Our Reference: WQUE-SA-12002

30 October 2012

Amendment to Clearing Permit (Purpose Permit) – CPS 5220/1 Western Queen South Gold Project

Figure 1: Revised Purpose Permit Application Area for Western Queen South Project

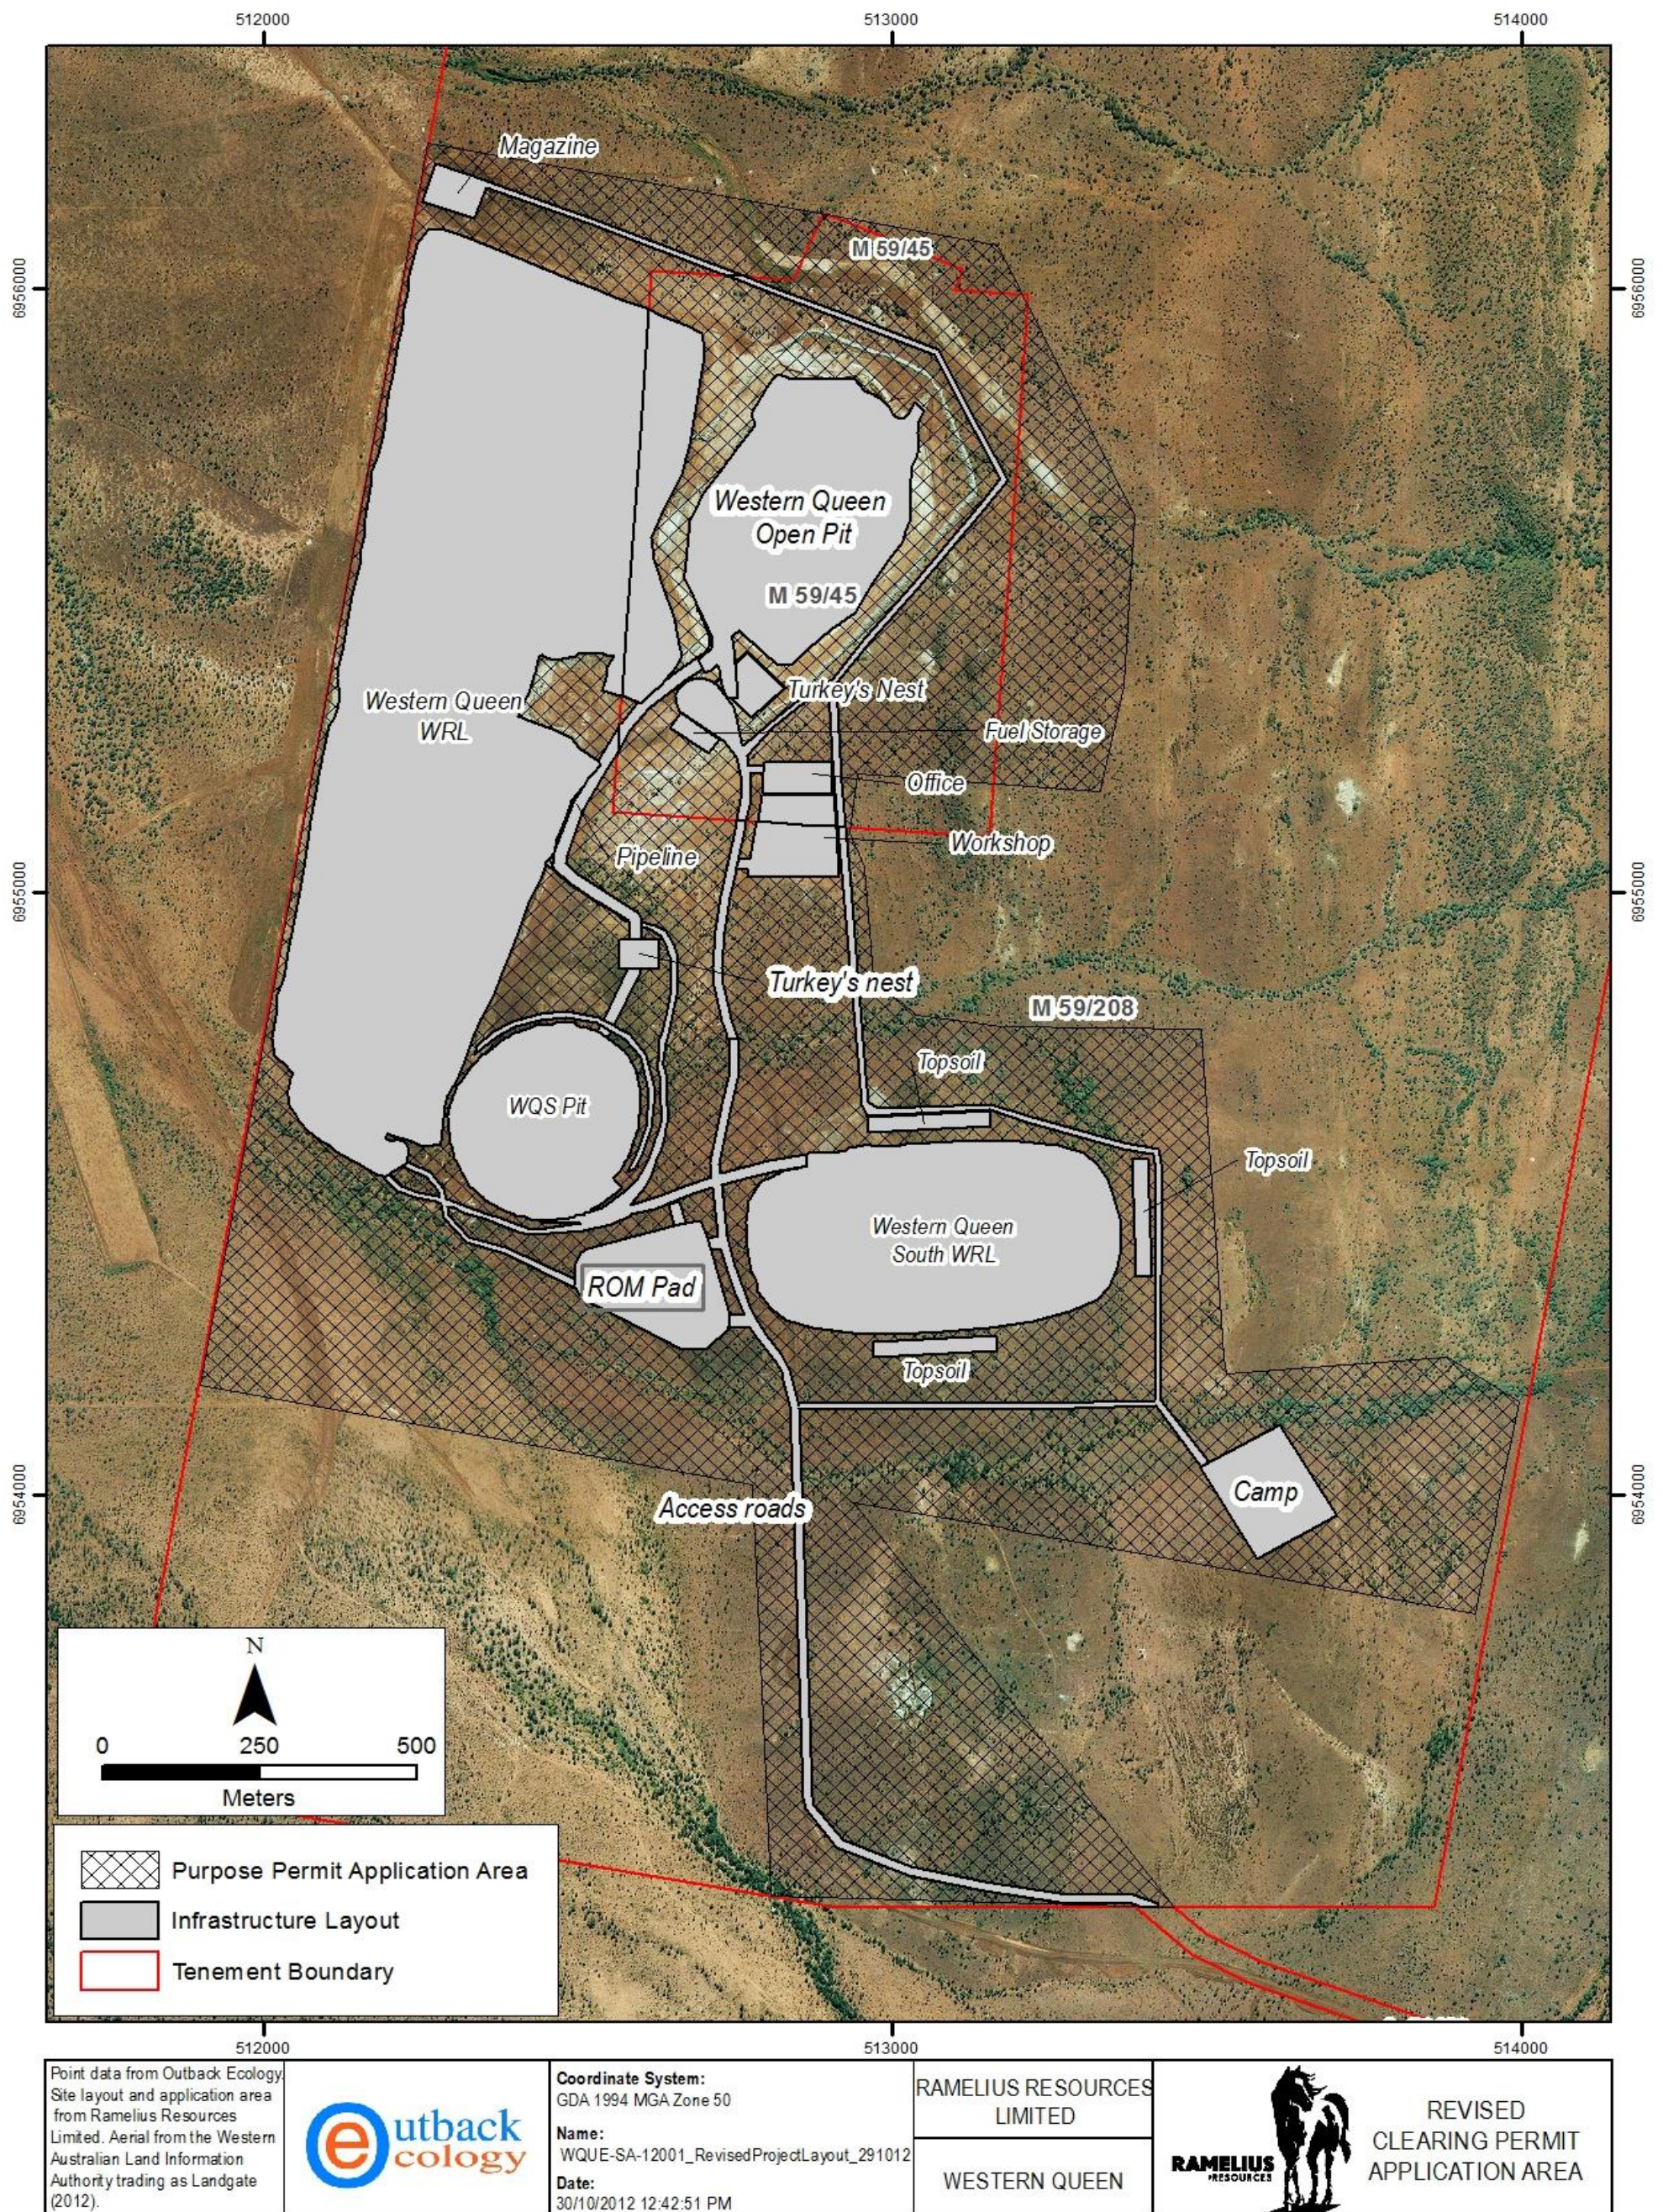
- The site layout has been changed as per the design shown in **Figure 1**. Changes include the addition of a second turkey's nest adjacent to the Western Queen pit and relocation of the workshop area. These proposed changes all occur within previously disturbed areas.

- The proposed location of the camp has also shifted slightly following further on site investigations for suitable substrate.
- To provide greater flexibility during operations MMG are seeking to change the permit application area to cover a wider area of 309 ha as shown by the cross-hatching in **Figure 1**.

- The initial clearing permit application included clearing areas only for those infrastructure proposed to be established on land that had not previously been disturbed. MMG are seeking to increase the number of hectares to be cleared from 25 ha to 45 ha. The proposed area of disturbance of native vegetation remains largely unchanged at 25.4 ha with the remaining 19.6 ha to take place on land previously disturbed by historic mining activities. An updated table of disturbance is provided at **Table 1**.
